MATANUSKA-SUSITNA BOROUGH

ABBREVIATED PLAT AGENDA

STAFF REVIEW AND RECOMMENDATIONS
PUBLIC HEARING
SEPTEMBER 18, 2024

STAFF REVIEW AND RECOMMENDATIONS
PUBLIC HEARING
SEPTEMBER 18, 2024

A PLAT OF RADFORD'S RETREAT 2024
A RESUBDIVISION OF LOTS 3 AND 4
RADFORD'S RETREAT, PLAT #2008-200
WITHIN THE
NE 1/4 SE 1/4 SECTION 28, T. 17 N., R. 2 W
SEWARD MERIDIAN, ALASKA
PALMER RECORDING DISTRICT
THIRD JUDICIAL DISTRICT
STATE OF ALASKA
CONTAINING 7.05 ACRES, MORE OR LESS

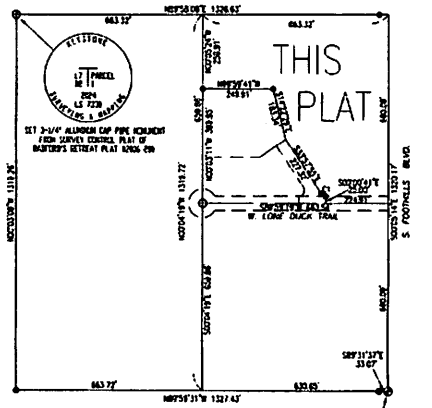
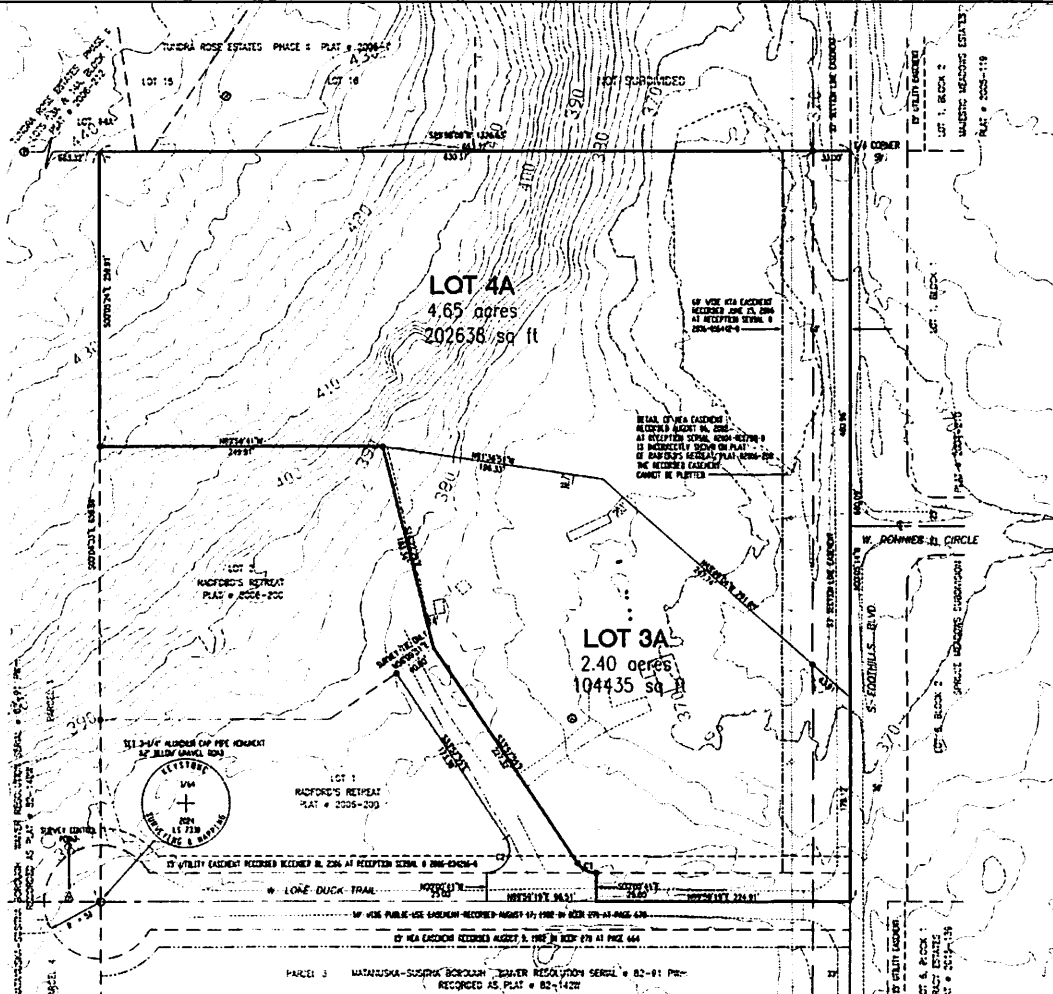
MBS Pre-Design and Engineering: (Exhibit C) As foothills is classified on the OSHP as a major collector, both lots should access Lone Duck Trail.

As foothills is classified on the OSHP as a major collector, both lots should access Lone Duck Trail.

ENSTAR Natural Gas Company, LLC has reviewed abbreviated plat **RADFORD'S RETREAT 2024 (MSB Case # 2024-089)** and advises that there is an existing natural gas service line which appears to cross proposed Lot 4A to serve proposed Lot 3A. Attached is an as-built for your reference. ENSTAR objects to this plat unless one of the following scenarios is met:

1. Add a note which says, "There is a ten foot (10 FT) wide natural gas easement centered on the existing service line." And draw in the location of the service line on the map and add, "Location of natural gas main and centerline of ten foot (10 FT) wide natural gas easement".
2. Owner signs an ENSTAR Natural Gas Easement document for a ten foot (10 FT) wide natural gas easement, centered on the service line at this location.

*Staff recommends petitioner record a natural gas easement and note easement on final plat.
Recommendation #5.*
